Vermont Granite Museum Ecological Restoration Plan

By
DuBois & King, Inc.

**Figure 10, VT F&W
Fisheries Comments**

Figure 5. Bike path plans – January 2014

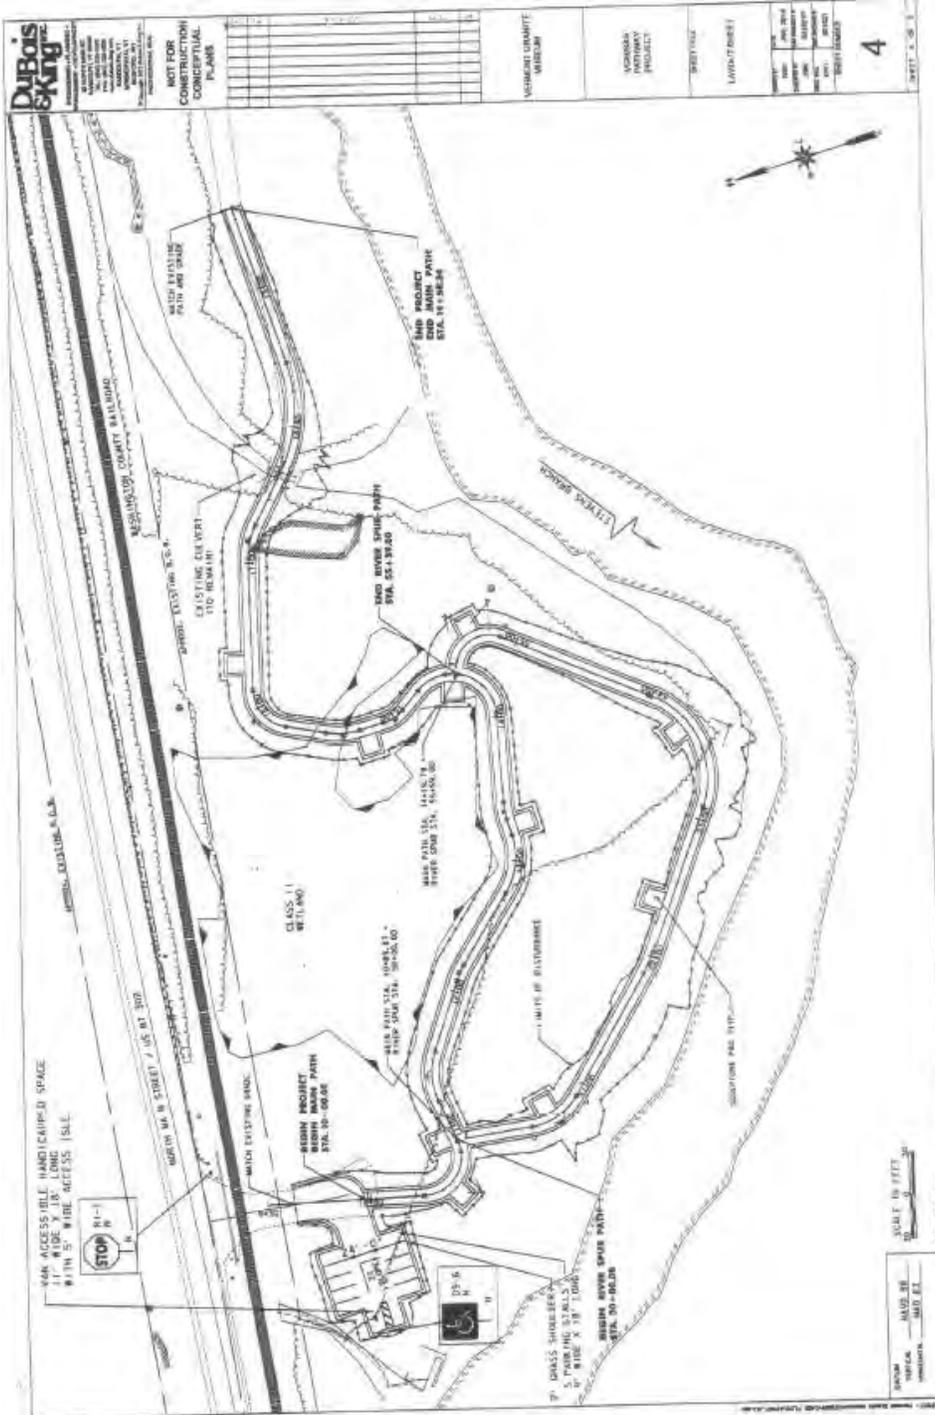
The most recent map provided by DuBois & King Inc. (Figure 5) does not include buffer measurements. The bike path should not be constructed within 50ft from the top of the streambank. You may also want to contact the Department of Environmental Conservation's River Management division (Gretchen Alexander 802.490.6150) for a determination of river corridor requirements.
